**Clinton Power Station**

Subject: Clinton Power Station Exemption Request and Proposed Amendment to Facility Operating License No. NPF-62 (LA-00-011)

## PROPOSED CHANGES TO THE CPS TECHNICAL SPECIFICATIONS

Figure 3.4.11-1 (page 1 of 1)  
RCS Pressure Versus Minimum Reactor Vessel Metal Temperature

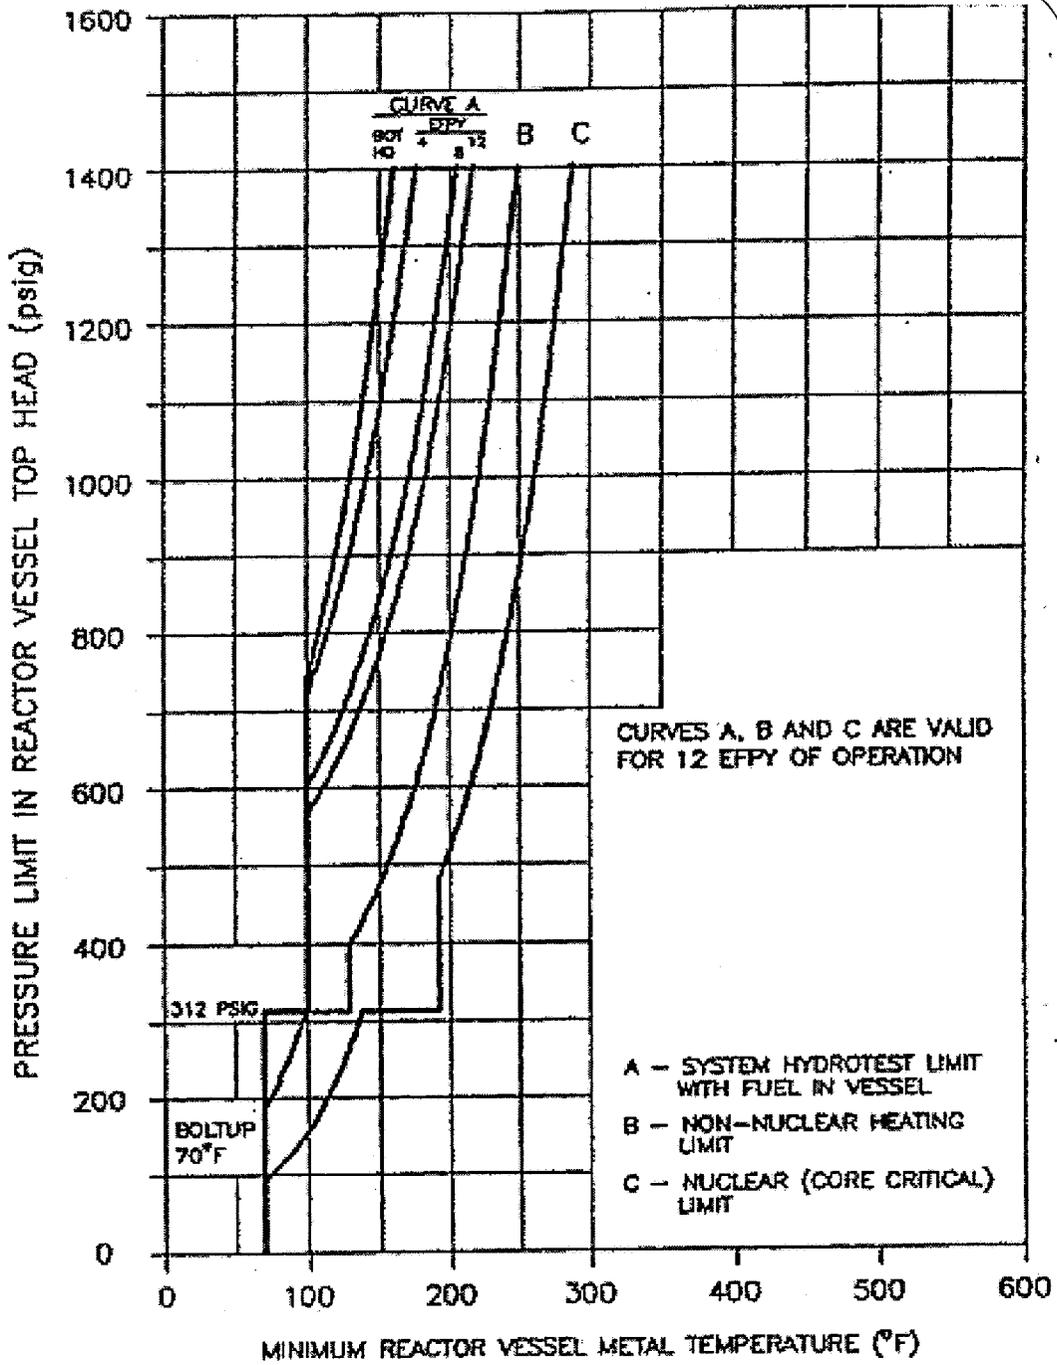
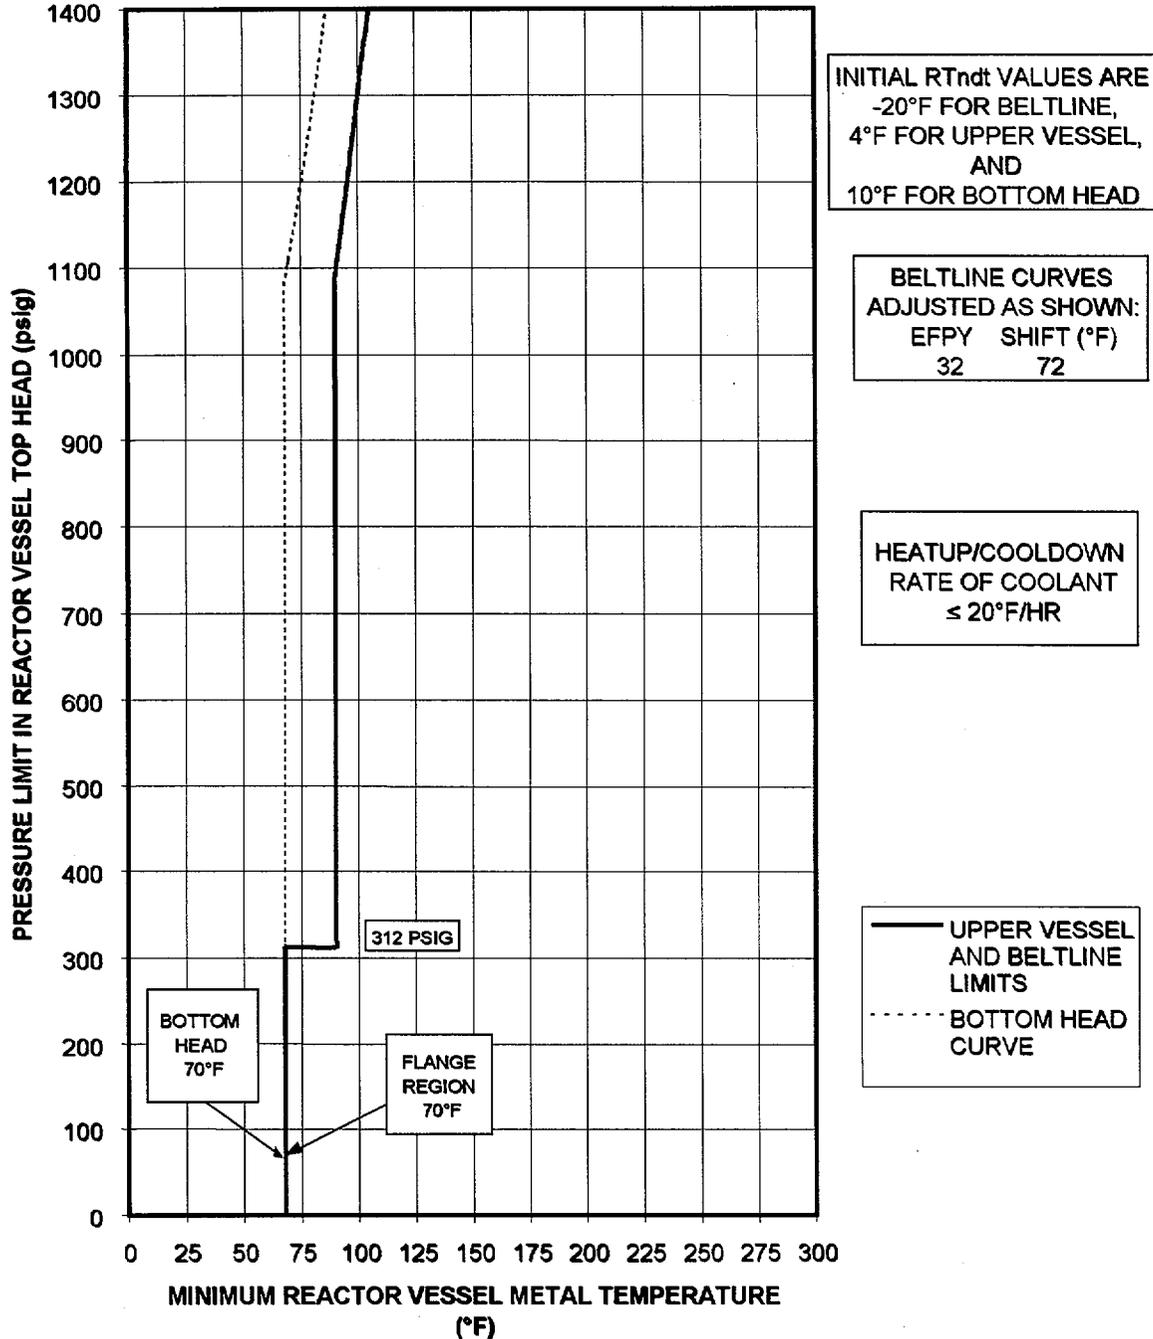
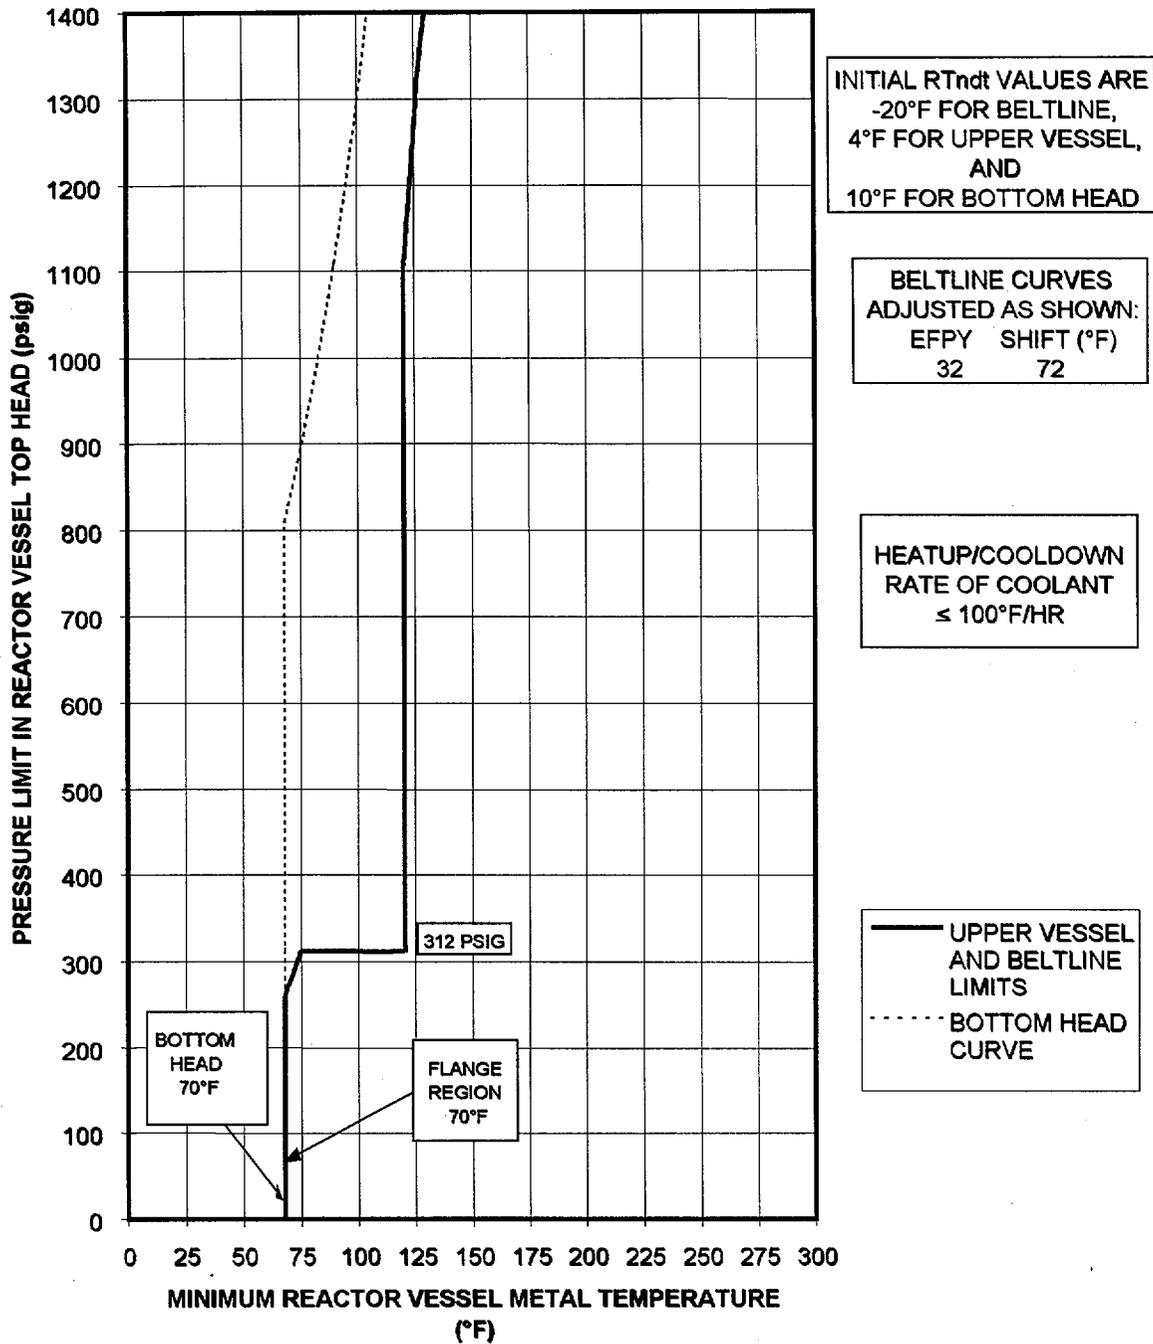
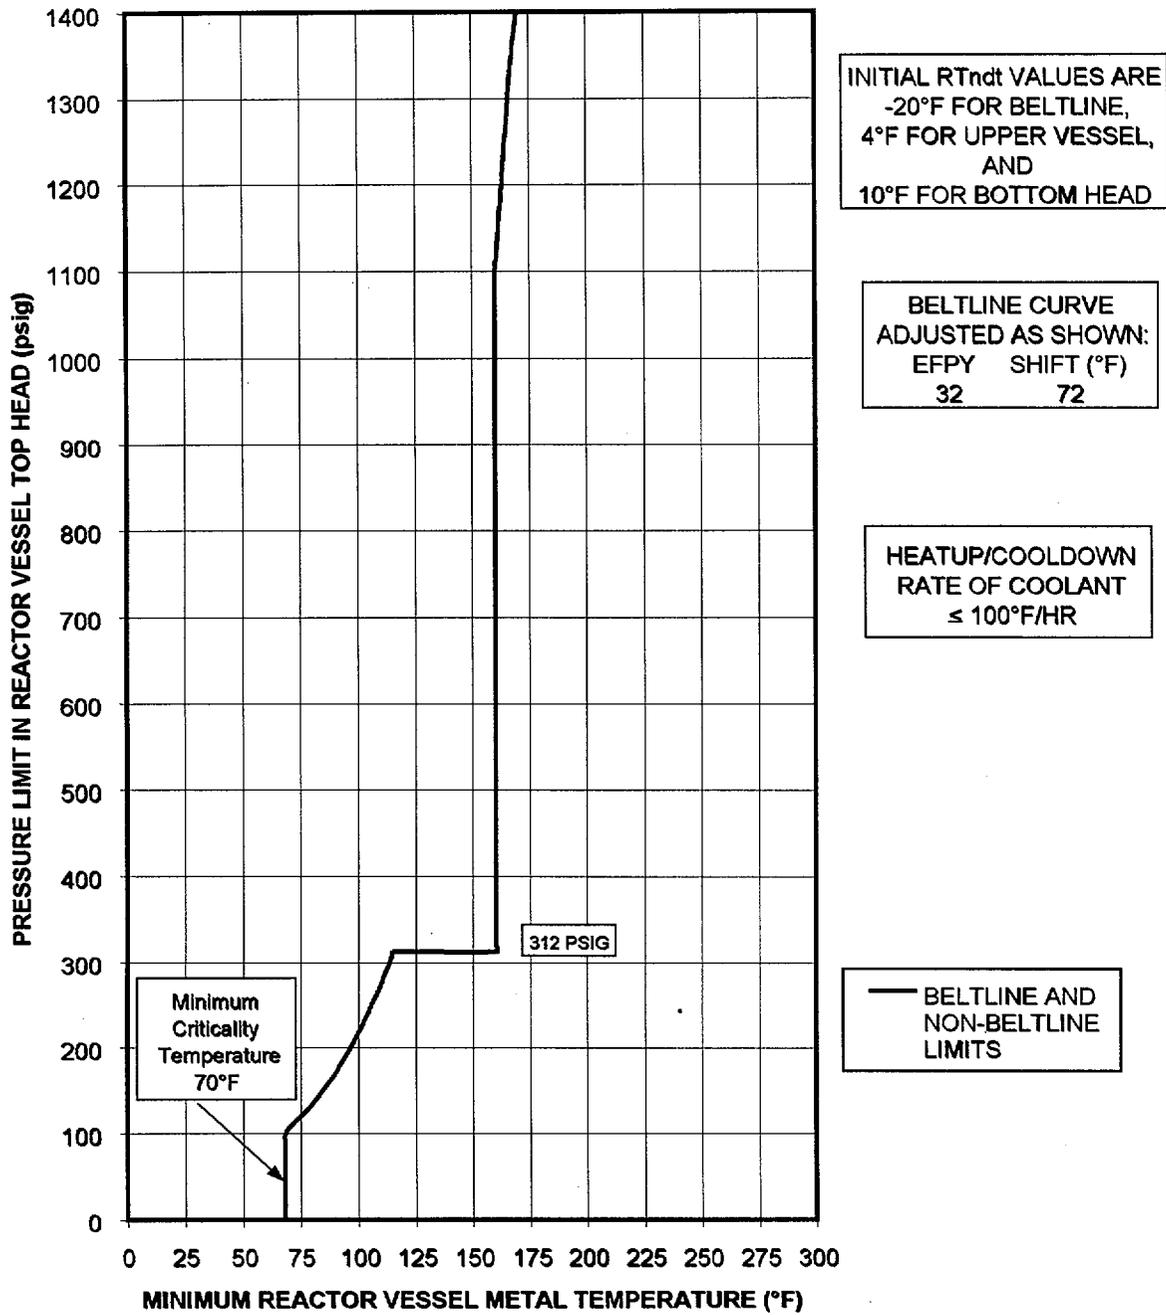
Attachment 3 indicates the proposed administrative changes to TS 3.4.11 and the replacement of Figure 3.4.11-1 with three figures:

- Figure 3.4.11-1, "Bottom Head and Composite P/T Curves For Pressure Tests [Curve A] Up to 32 EFPY,"
- Figure 3.4.11-2, "Bottom Head and Composite P/T Curves for Core Not Critical Operation [Curve B] Up to 32 EFPY," and
- Figure 3.4.11-3, "Composite P/T Curves for Core Critical Operation [Curve C] Up to 32 EFPY."

The current pressure-temperature (P-T or P/T) limits specified per Figure 3.4.11-1 are indicated via several curves on a single figure, for the various operating and/or test conditions. The current curves are to be replaced with recalculated curves on separate figures, and the associated descriptions contained on the figures are to be revised as well. Revised TS Figure 3.4.11-1 will have a curve for the bottom head region of the vessel and a composite RCS curve (excluding the bottom head) for hydrostatic testing and leak testing conditions for an exposure level up to 32 effective full power years (EFPY). Figure 3.4.11-2 will have a curve for the bottom head region of the vessel and the composite RCS curve (excluding the bottom head) for non-critical operation for up to 32 EFPY. Figure 3.4.11-3 will have a curve for the entire RCS for reactor critical operation for up to 32 EFPY. These curves for specifying the required temperature limits will continue to ensure margin to the brittle fracture temperature, i.e., the nil ductility temperature, for the noted operations or conditions. One of the primary effects of the revised curves is to permit reactor vessel inservice hydrostatic and leak tests to be performed at a lower temperature at applicable vessel pressures.

Figure 3.4.11-1  
Bottom Head and RCS Composite P/T Curves  
for Pressure Tests [Curve A] up to 32 EPFY

Figure 3.4.11-2  
Bottom Head and RCS Composite P/T Curves  
for Core Not Critical Operation [Curve B] up to 32 EFPY

Figure 3.4.11.3  
RCS Composite P/T Curves for Core Critical  
Operation [Curve C] up to 32 EPFY
